# South Carolina Building Codes Council 2021 Proposed Modifications

## 7/27/21 Study Committee Meeting

## 2021 International Residential Code South Carolina Building Codes Council Modification Continuations from 2018

**2021 Code Section:** Figure R307.1 Minimum Fixture Clearances

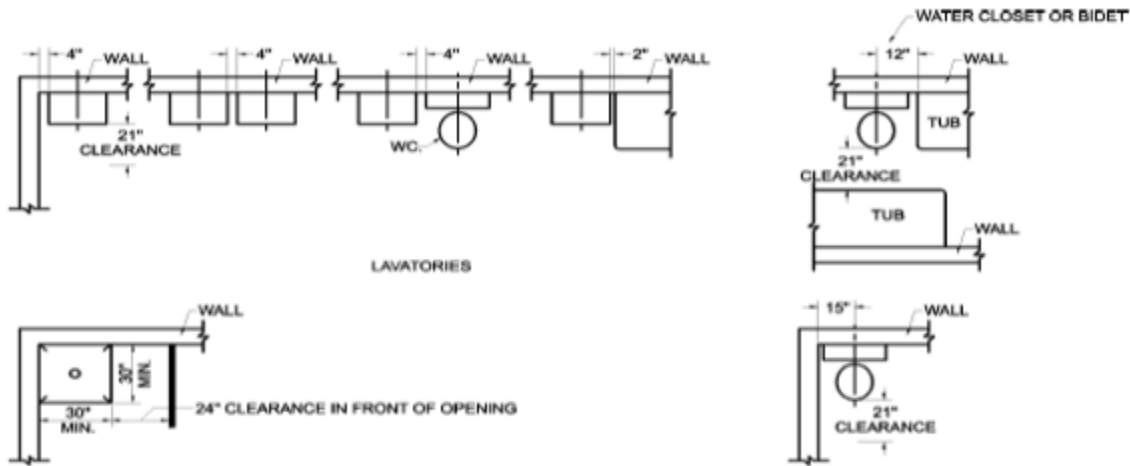
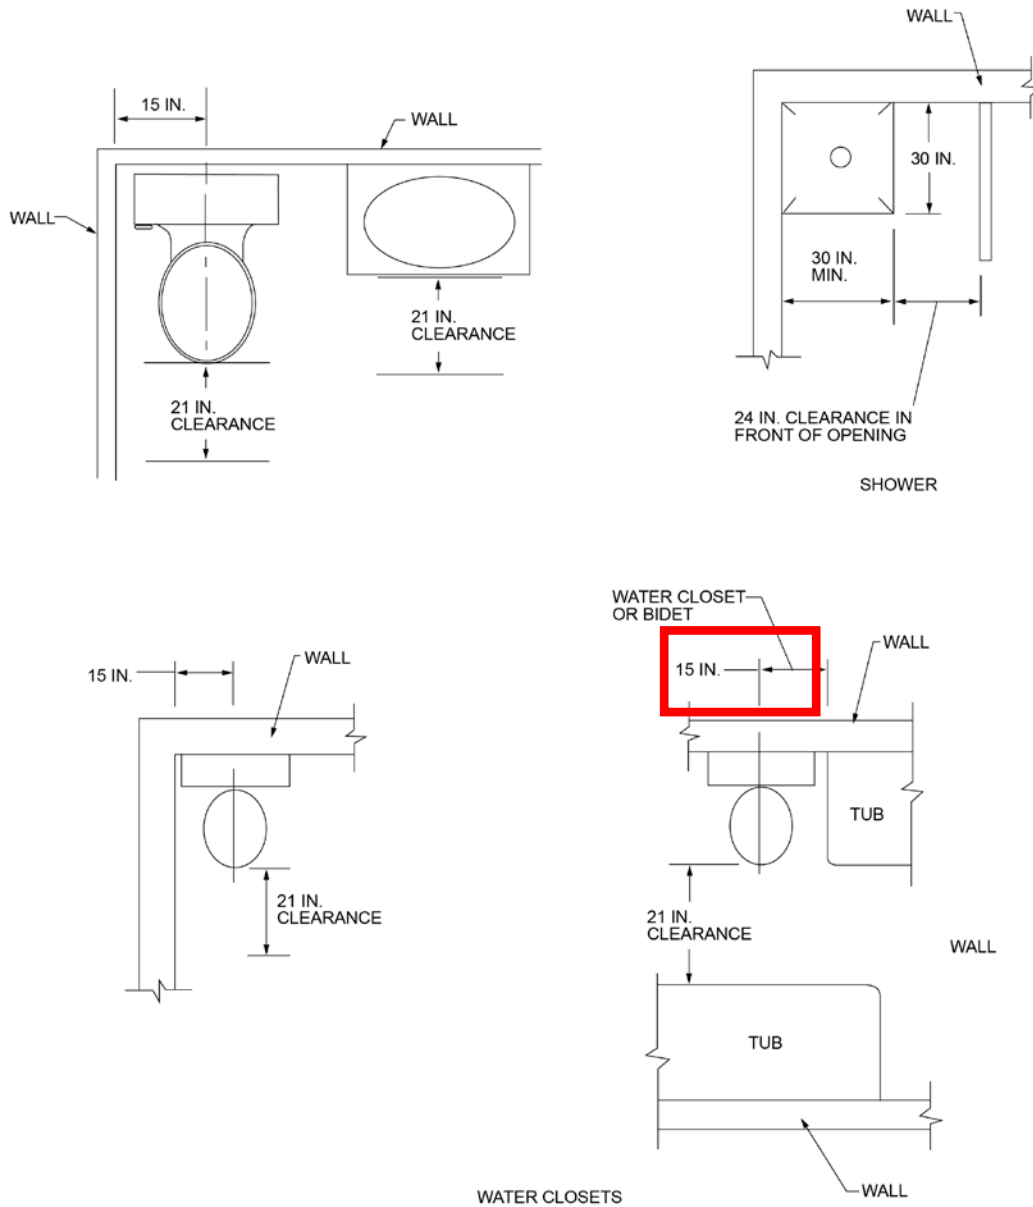
**Modification:** Change the minimum dimension for the side clearance between bathtubs and water closets and bidets from 15 inches to 12 inches.

**Comments:** See clerical correction above. Also, this is a very old chart. Newer chart should be easier to use and just change 15 inches to 12 inches. Figure is also 307.1, not 307.2

7/27: Approved with use of updated drawing (next page) with adding part in red to 12 inches. Clerical error noted above about "Figure" also approved.
